AERONAUTICAL CHARTING MEETING
Charting Group
Meeting 23-02 – October 24-26, 2023

RECOMMENDATION DOCUMENT

FAA Control #23-02-380

Subject: Modification of contour depictions on Instrument Approach Procedures (IAP) charts

- Example of proposed changes to contours on MSO RNAV (RNP) Rwy 30:

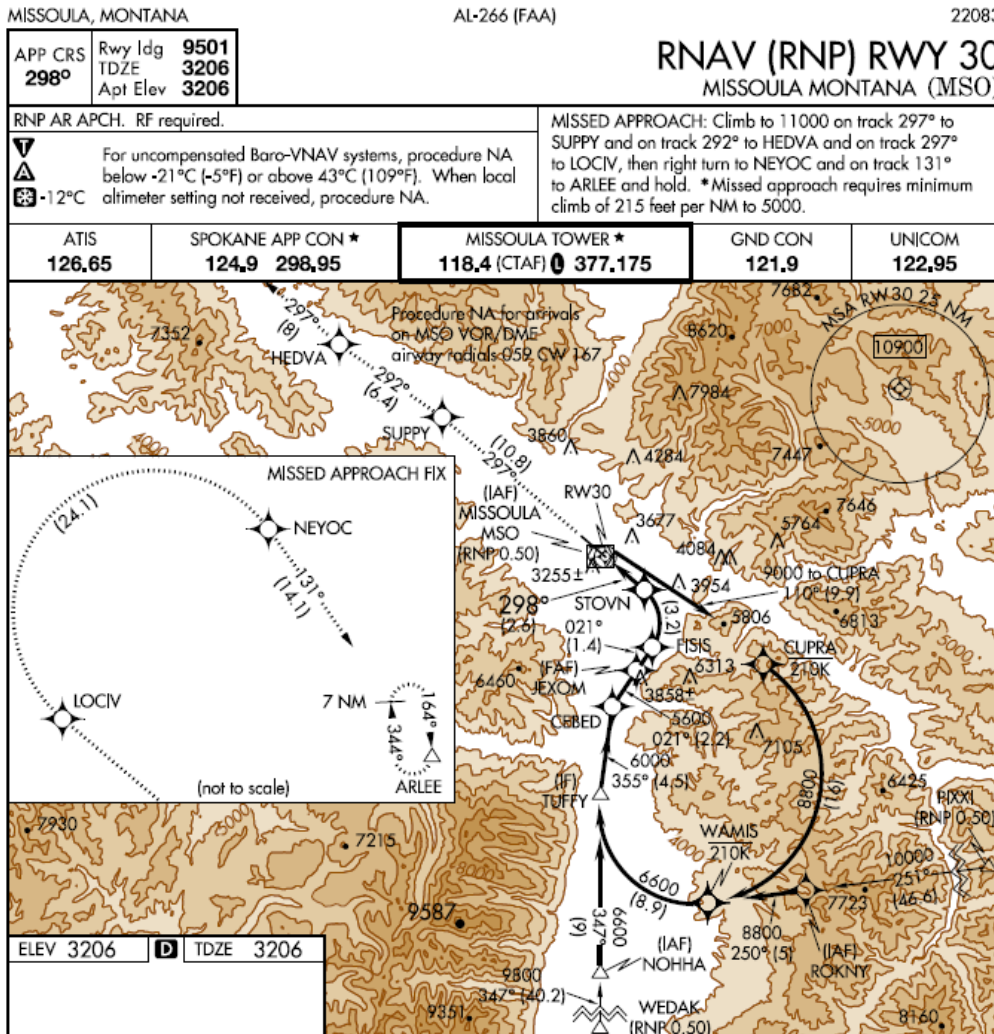
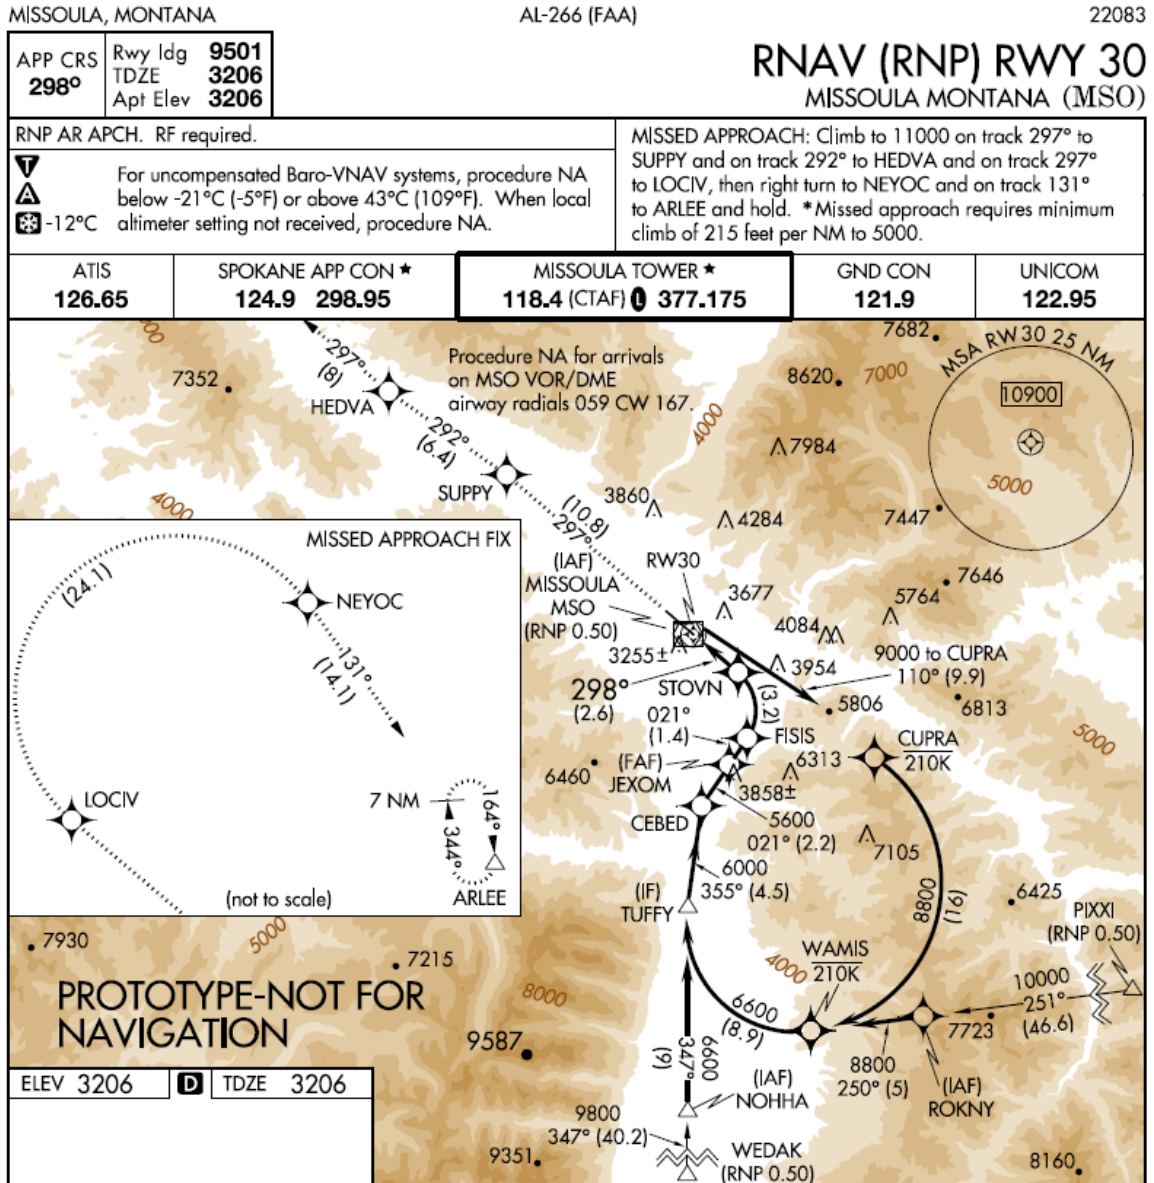
Terminal Charting would like to propose a change to the depiction of contours on IAP charts. As charts become more complex, the current depictions of contours on IAP charts, especially ones that are heavily congested, introduce clutter that obstructs procedural data and makes the charts difficult to read and understand.

- Example of current depiction of contours on MSO RNAV (RNP) Rwy 30:

On IAP charts that require terrain, Terminal Charting proposes the removal of the contour interval lines to enhance the readability of the chart while preserving the contour intervals themselves.

Rich Boll, NBAA, thanked Krystle for bringing this recommendation and said he strongly agrees with this change. He pointed out that in the MSO example, it is almost impossible to read the procedural information on the chart, especially in low lights in the cockpit. He said he hopes Jeppesen will also make this change on their charts. Rich asked if charting had looked at the prototype charts in the various digital displays. He said they do not look the same when they are on paper as they do on digital displays in the airplane. Krystle said they have not investigated how the contours look on the digital displays.

Doug Willey, ALPA, said he supports the change, however he also suggested looking at the night function of the electronic displays to see the impact of the removal of the lines.

Jennifer Hendi, FAA/AJV-A250, said we do have contacts at the Volpe Center and she will take an action item to reach out to them about how these changes will look in EFBs. If deemed acceptable, Terminal Charting can proceed with an Interagency Air Committee (IAC) Specification change to remove the contour lines from IAPs. Jennifer said she will also have to file an ICAO difference to Annex 4 since it specifically states elevations shall be shown by smooth contour lines.

More examples of targeted cluttered areas:

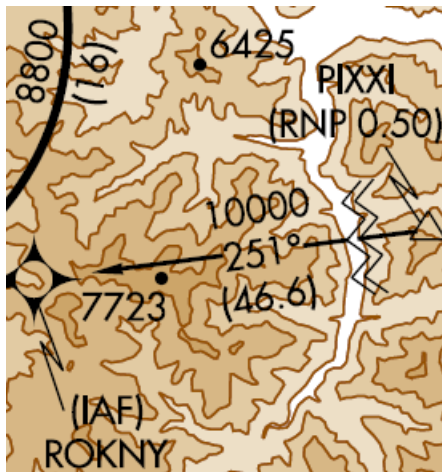
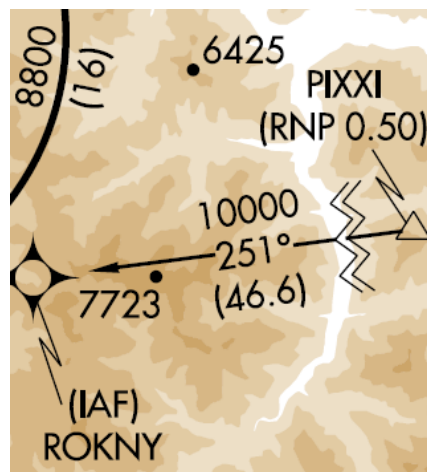
On some of the examples above, it is very difficult to even read the names of fixes or discern the routes on the current charts. Not having the interval lines depicted makes it significantly clearer to read the same information.
